**Operating Facilities – Operating Reactors**

**Fault Studies Assessment of the Hunterston B R4 Return to Service Safety Case  
Following Core Inspection Results in 2018**

Assessment Report ONR-OFD-AR-19-029  
Revision 0  
08 July 2019

**Figure 2 – A Stage 2 Fuel Element**

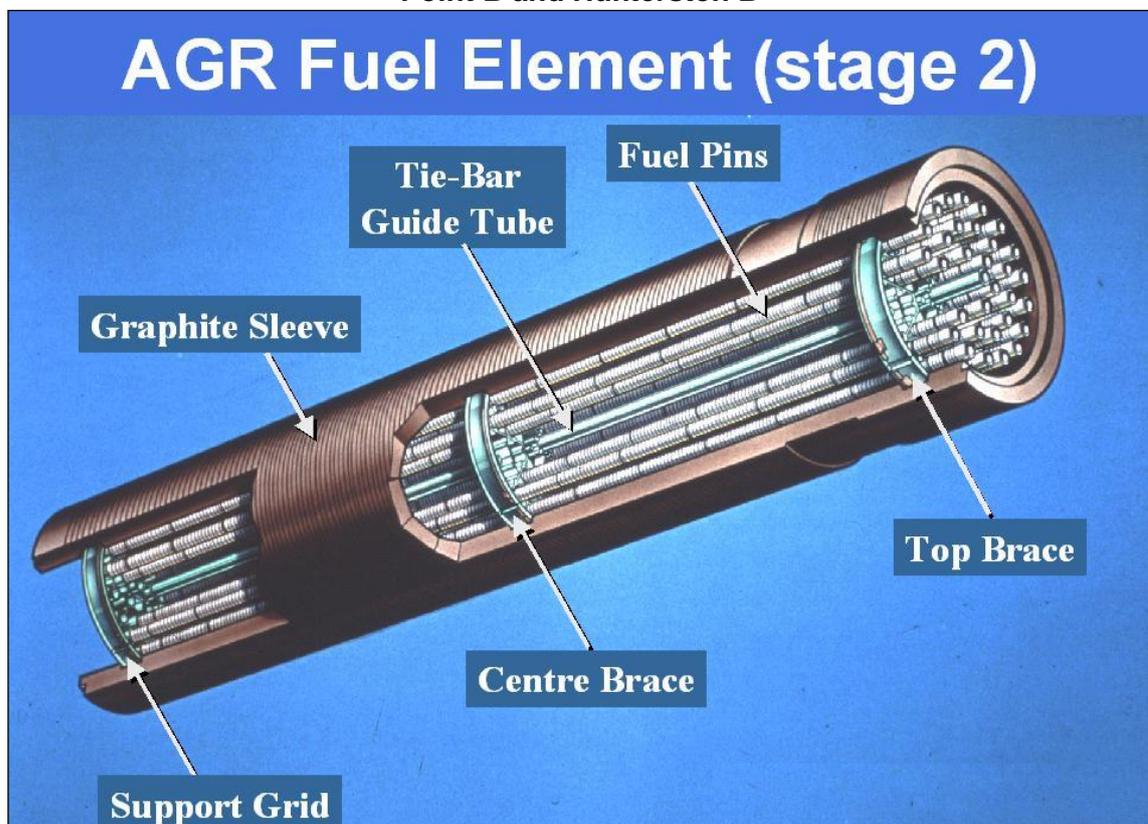
46. NGL argues that the most significant concern relating to graphite debris is the potential for debris to become lodged at the fuel element support grid (Figure 2), and that 16.5% of the flow area of the stringer would need to be blocked before the fuel clad temperature limit was reached. NGL states that it is not considered credible for more than 16.5% of the flow area to become blocked by graphite debris.

175. The fuel element support grids and fuel braces (Figure 2) hold the fuel pins in place, and the structure required to do this restricts the space through the grids and braces. The fuel element support grids have smaller spaces in them than the fuel braces, and thus if debris were to pass through the support grid then it is unlikely to become stuck in a fuel brace. The element 1 support grid is considered here as it is the first support grid or fuel brace in the flow path up the fuel stringer and thus larger items of debris are likely to become stuck there. If debris is small enough to pass through the element 1 support grid then the most onerous location that it could become stuck is then an element 6 support grid or fuel brace; this is considered later in this section.

239. Reference 35 presents the results of analysis based on rig tests of the effects of debris at the peak rated location in a fuel stringer - the element 6 top brace (see figure 2). Reference 35 examines the effects of a blockage of an entire section of the top brace (figure 7) and determines that the fuel clad temperature remains below the Technical Specification Limit (870°C) at the peak rated location, accounting for the uncertainties in the analysis.

Figure 5 – Flow resistance as a function of sleeve gap size

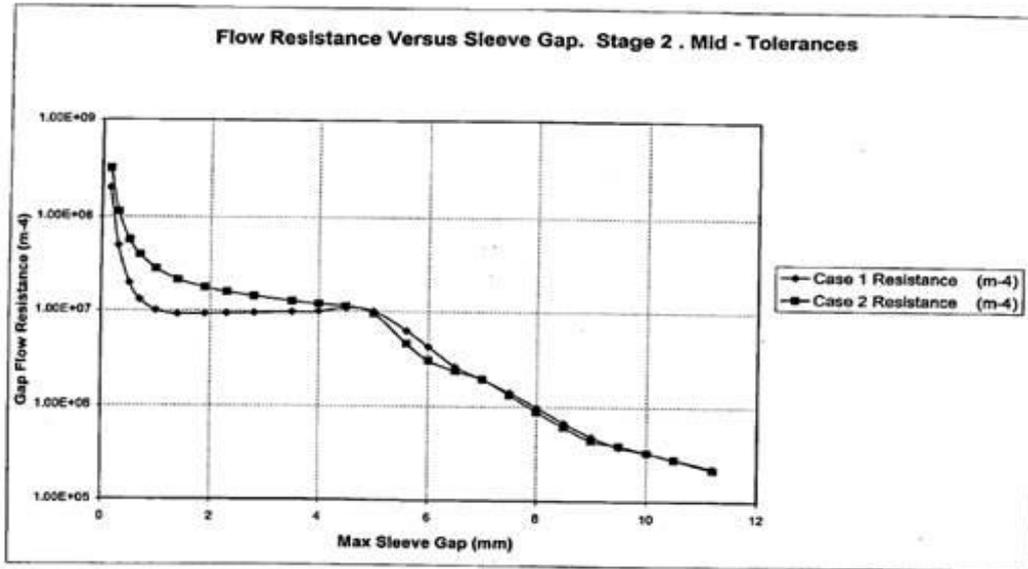
161. In response to my question NGL stated (Ref. 10) that there is good agreement with experimental results for gap sizes of 1mm, and that predicted sleeve gap flow resistances are nearly constant between 1mm and 5mm sleeve gaps (Figure 5) and that this makes sense physically as the spigot is still engaged over this range of gap sizes (Figure 6) leading to a roughly constant flow area. As such NGL argues that it is highly likely that uncertainties of an order of magnitude would be bounding for wedge shaped gap sizes <5mm.
